# Accessibility Assessment and Recommendation Report

**Pilu Restaurant, 80 Undercliff Road, Freshwater NSW**

Report Number: RE220643 Access

Revision: 02

Figure 8- Proposed accessible entry to the pavilion

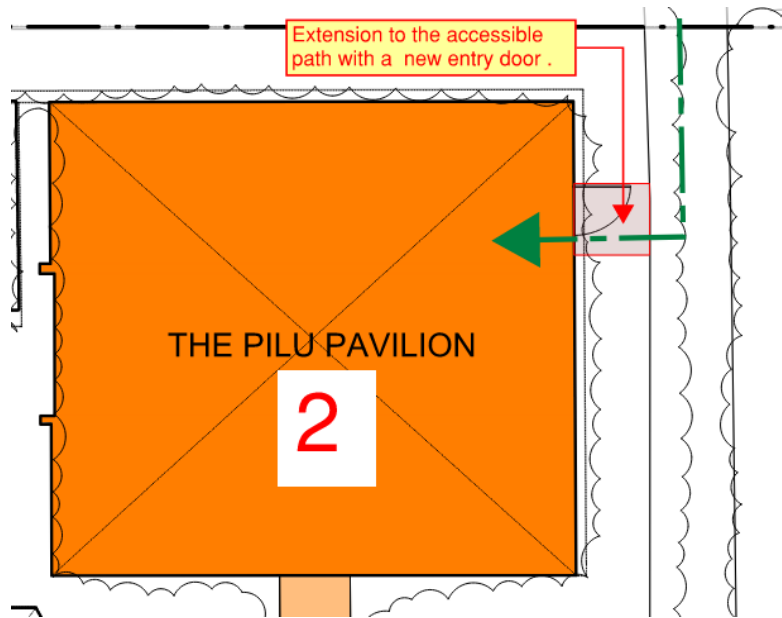
Though the pavilion is proposed to be used for special occasions such as wedding ceremonies, an accessible path of travel is not available for a wheelchair user to enter and exit the pavilion building ( Refer to Figure of this report).

The Finished Floor Level (FFL) of the pavilion is 500mm below the pathway at the entry point and access to and from the pavilion is provided via steps limiting wheelchair users' entry to the pavilion. Therefore the accessible path of travel to the building is not provided in accordance with Clause D3.2 (i), (ii) and (iii) of BCA for the use of people with disabilities, especially wheelchair users.

Being a significant space used by the public, an accessible path of travel must be established between the walkway and the pavilion. There are two recommendations to achieve access to the pavilion as below.

As the level difference is approximately 500mm, no recommended mobile ramps are available to provide safer access for wheelchair users. A 1: 14 ramp is impractical, requiring 7.0m as a ramp length.

Access via a new entrance to the pavilion with an extension to the walkway can be considered a reasonable solution ( Refer to Figure 8 below). The position of the door can be at a location where the FFL of the existing access path is equivalent to the FFL of the pavilion.

**Note:** The new sliding or swing door width, door clearances and the width of the extension of the accessible path shall be designed in accordance with the requirements of AS1428.1.2009.

The existing stepped entry can be used as an entry for everyone except for people using wheelchairs.

*Figure 9- Access to the Restaurant from Undercliff Road.*

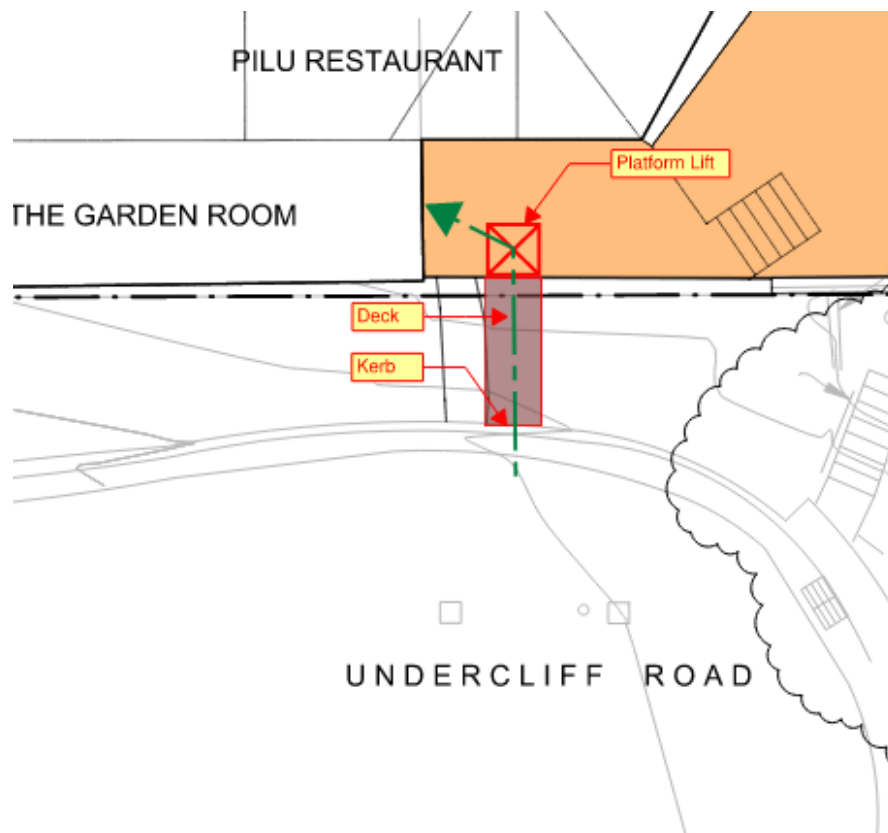
The main entrance to the restaurant is provided via an accessible path of travel up to the ground-level restaurant lobby and reception area. The main restaurant, which is at the upper level of the building, is accessed via the timber stair, limiting access to the restaurant for wheelchair users.

Therefore the *Deemed to Satisfy* provisions of BCA Clause D3.2 is not satisfied.

An accessible path of travel could be obtained via a platform lift installed within site with a path of travel (deck) beyond the boundary of the premises. As the level difference between the road and the deck in front of the 'Garden Room' is less than 1000mm (approximately 750mm at the steep ramp area), a platform lift can be considered an option.

Constructing a path of travel beyond the property boundary may need permission from the council.

As the main entrance to the buildings is from the carpark over Moors Road, and accessible parking is not provided within the cul-de-sac of Undercliff Road, it may not gain any customer advantage unless it is used as a drop-off area for people with disabilities.

This option can be considered a secondary option to access Pilu Restaurant when major refurbishment occurs within the complex.
